February 1, 2023

Lenoir County Administration Building – Interior Renovation

ADDENDUM NO. 2

Sheet E0.2

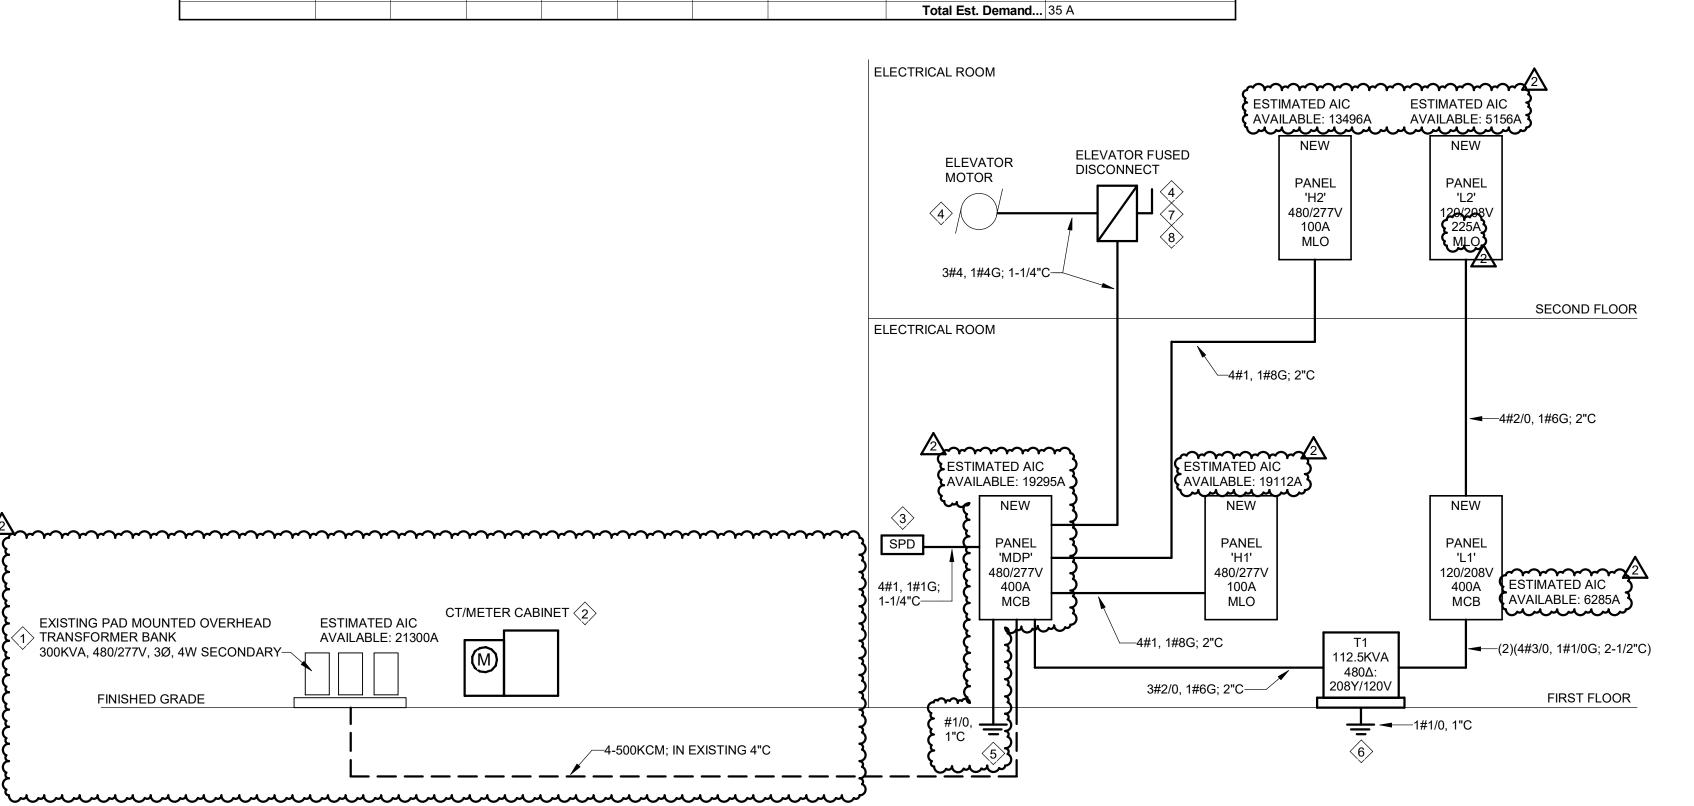
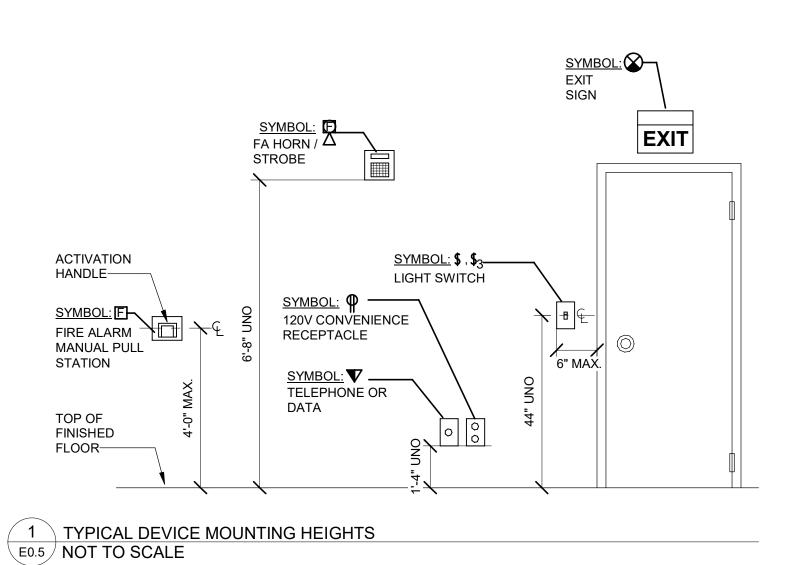
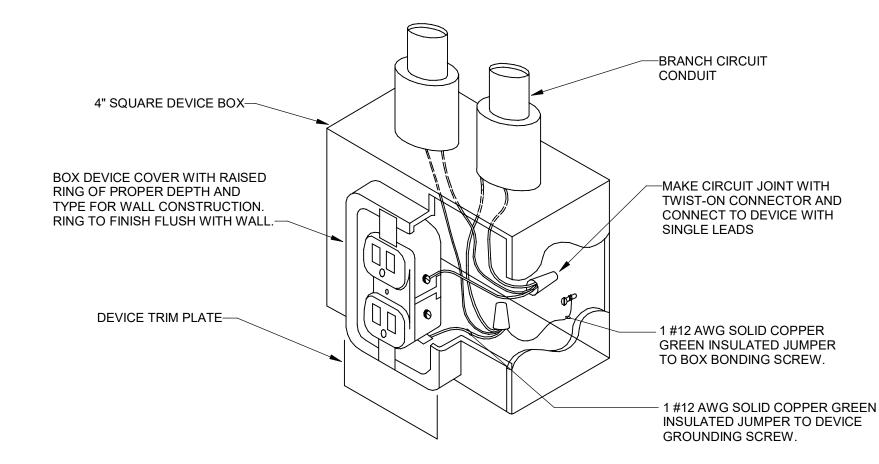
- Updated power riser diagram to match existing service.
- Updated estimated AIC for panels.
- Removed main disconnect mounted to exterior of building.
- Increased minimum SCCR for Panel H1.
- Included note on 'MDP' panel schedule to provide 100% SE rated main circuit breaker.
- Updated panel schedule 'L1' for three new circuits for door power.

Sheet E0.5

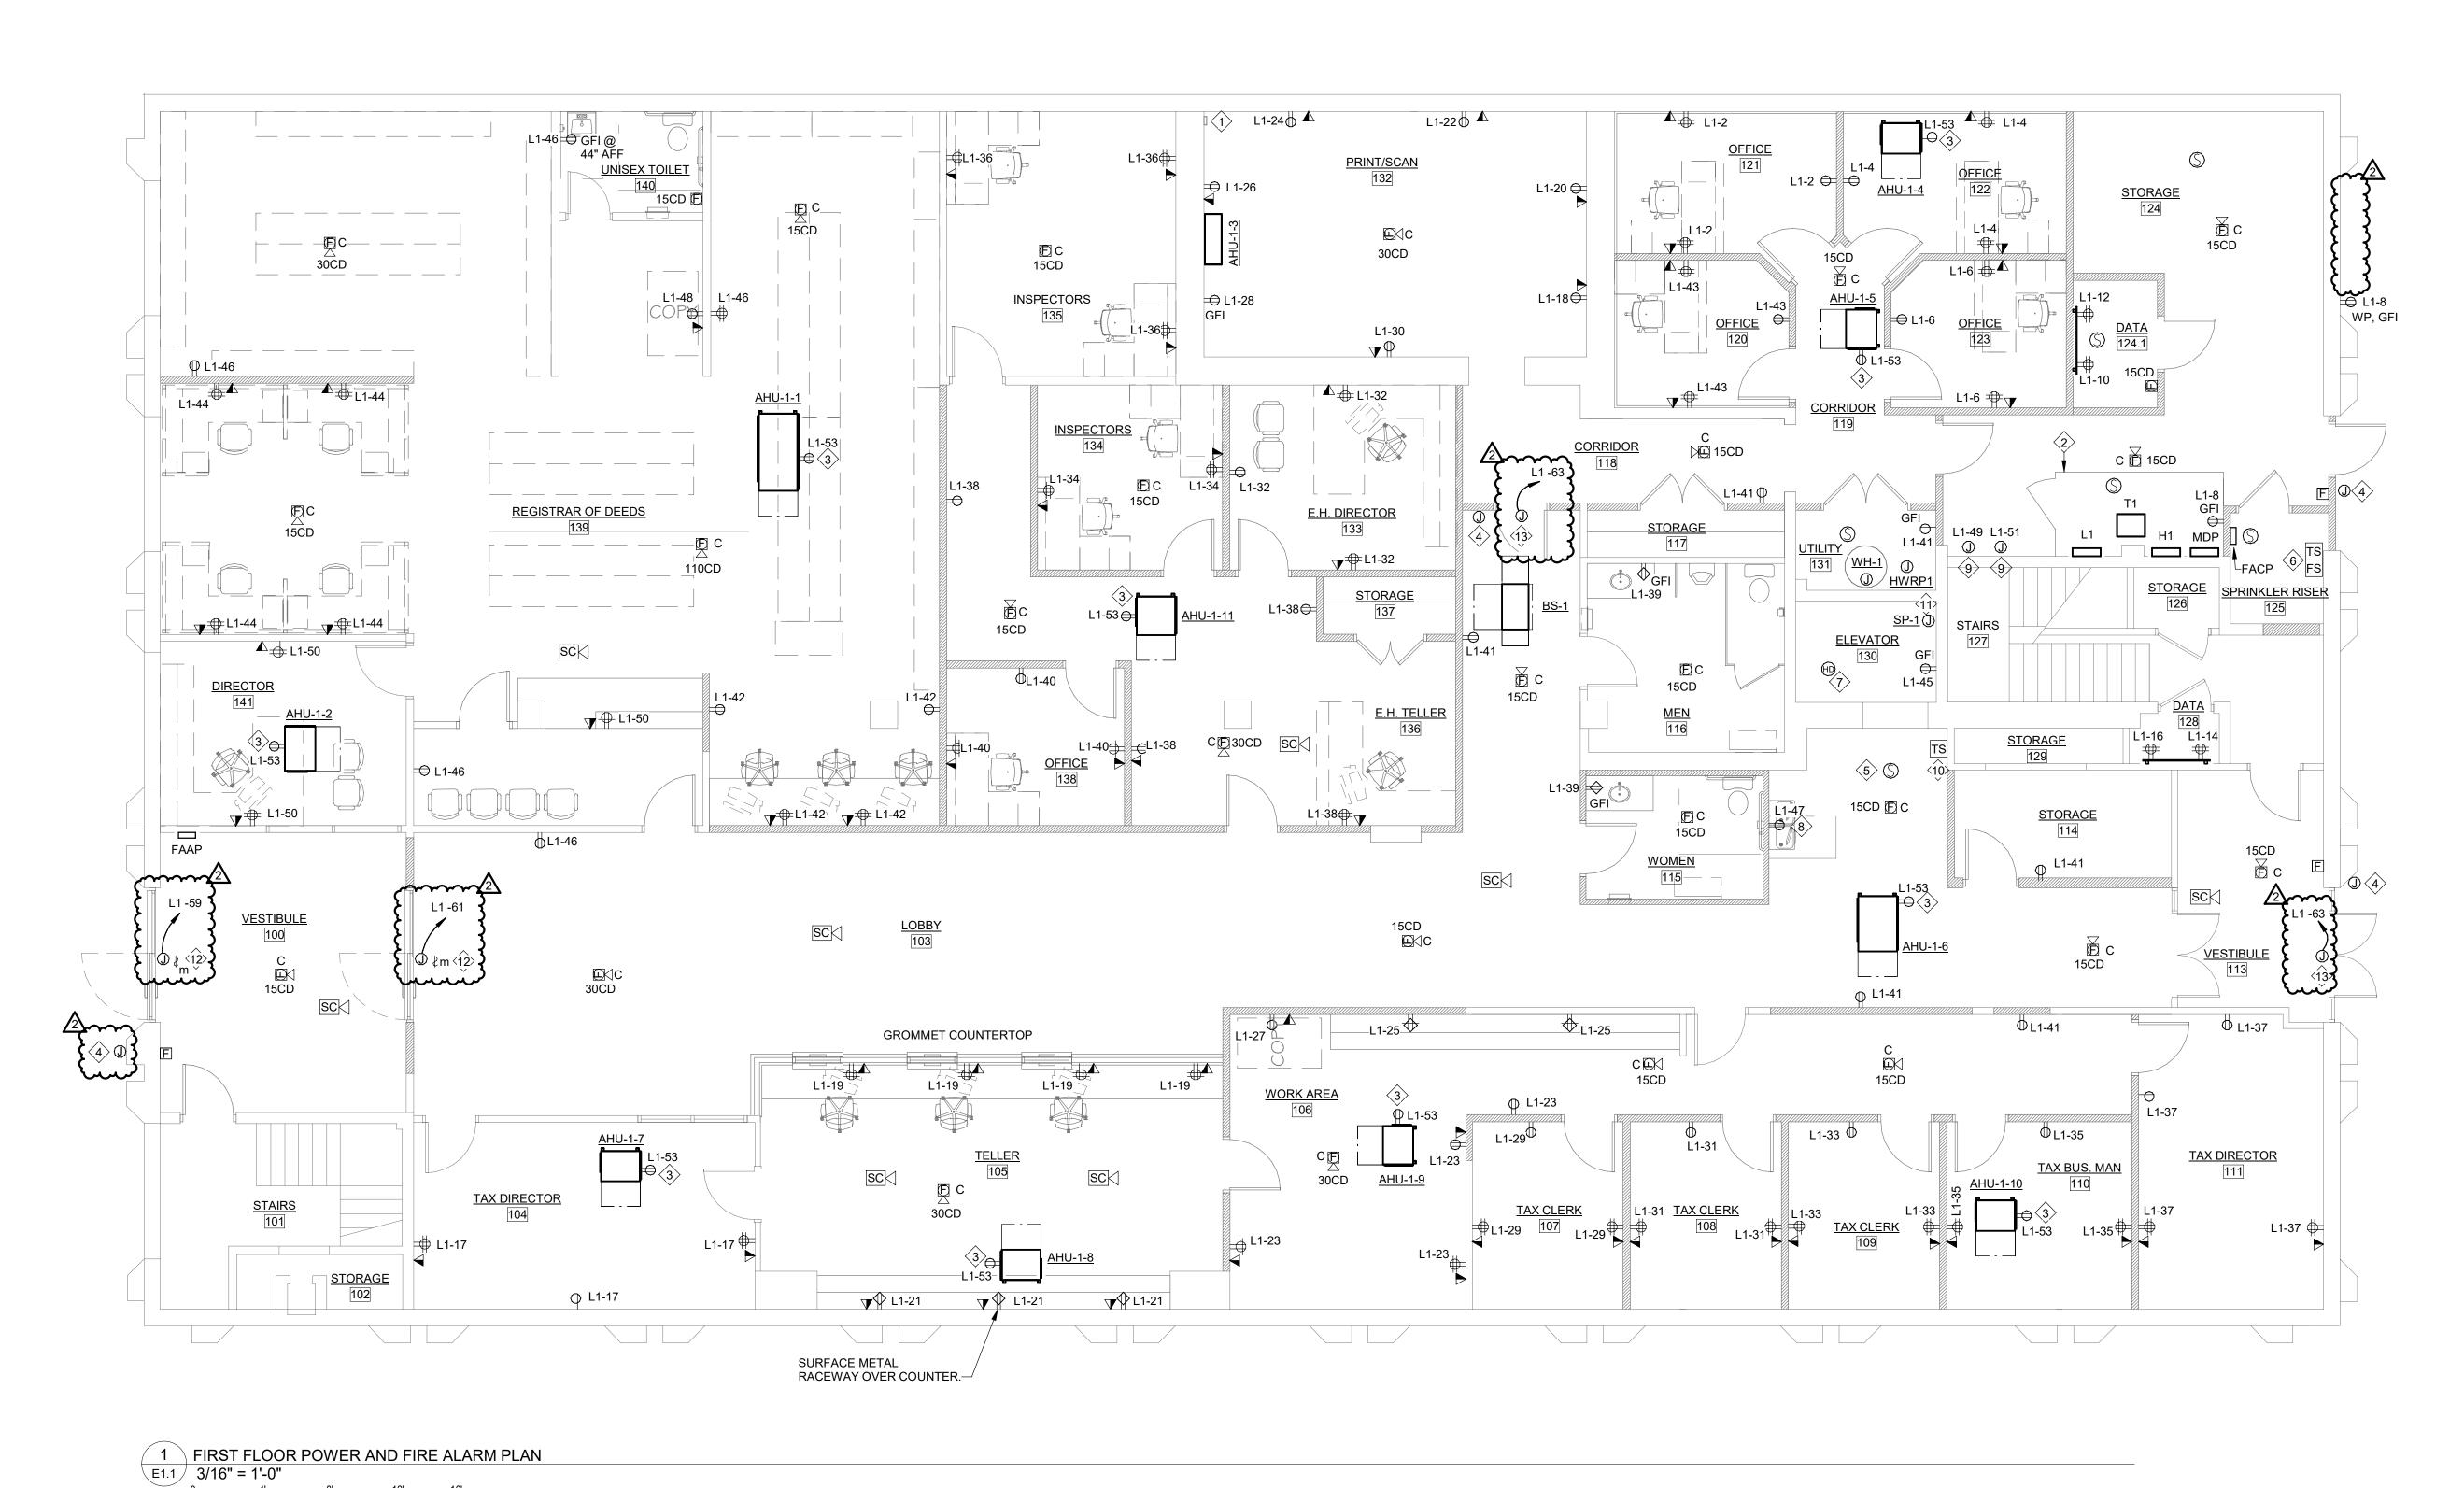
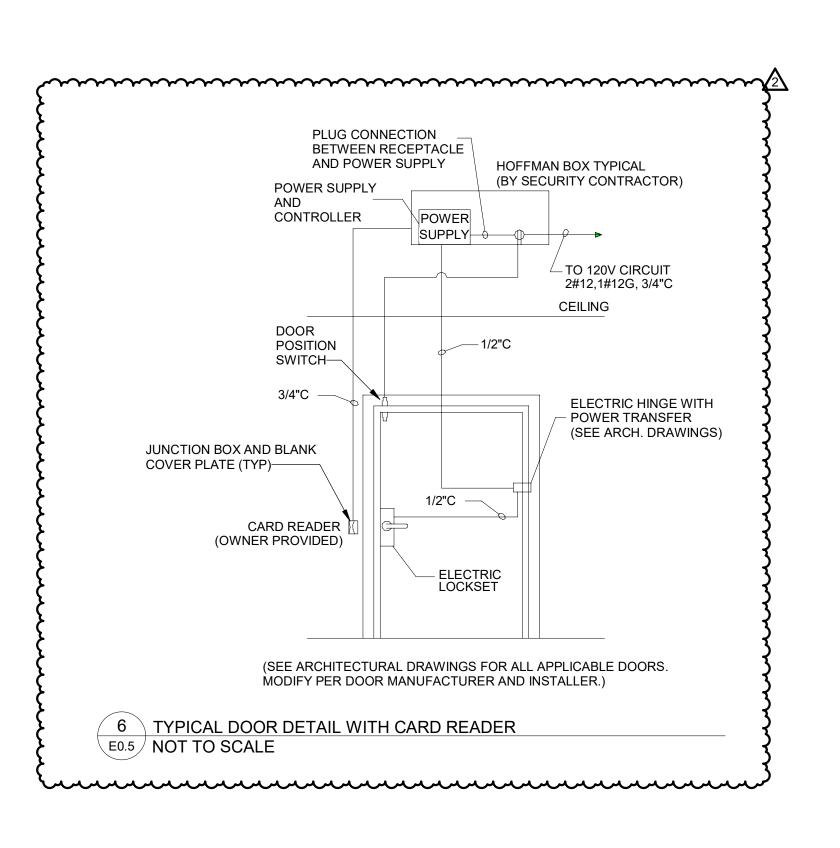
- Provided new detail for locating existing utility transformer, utility meter, and cooling tower in relation to building.
- Provided new typical detail for door access power.

Sheet E1.1

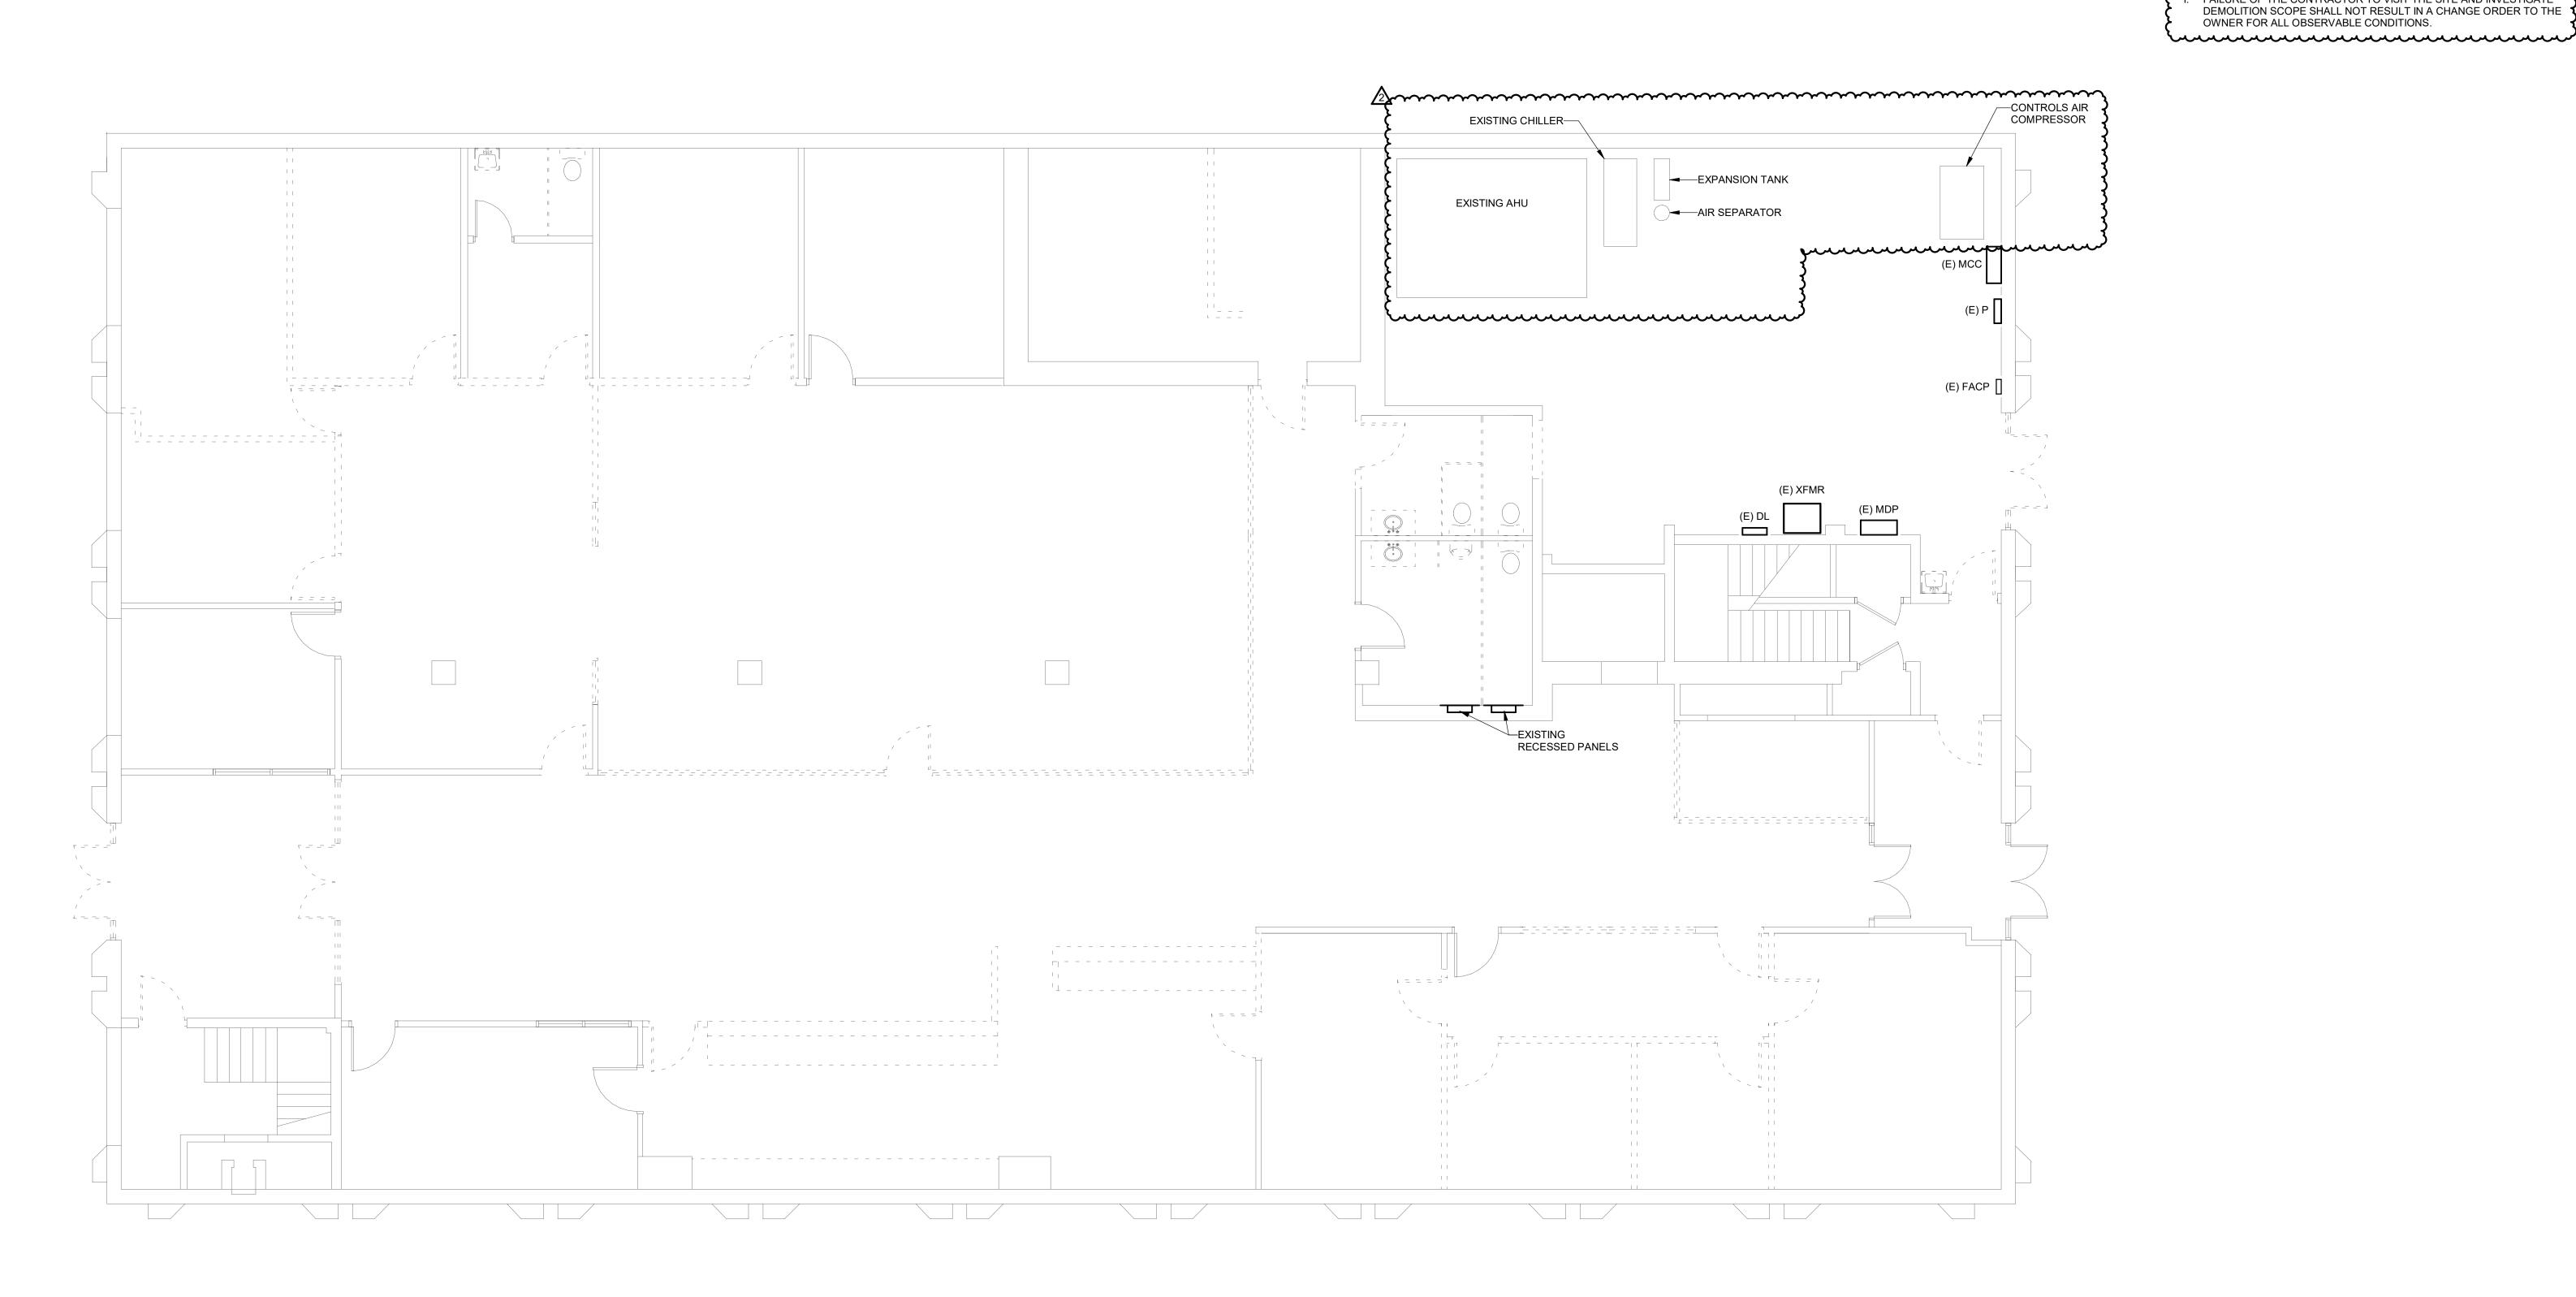
- Removed main disconnect and meter cabinet mounted to exterior of building.
- Added power and card access for exit doors.
- Added notes regarding power to exit doors.
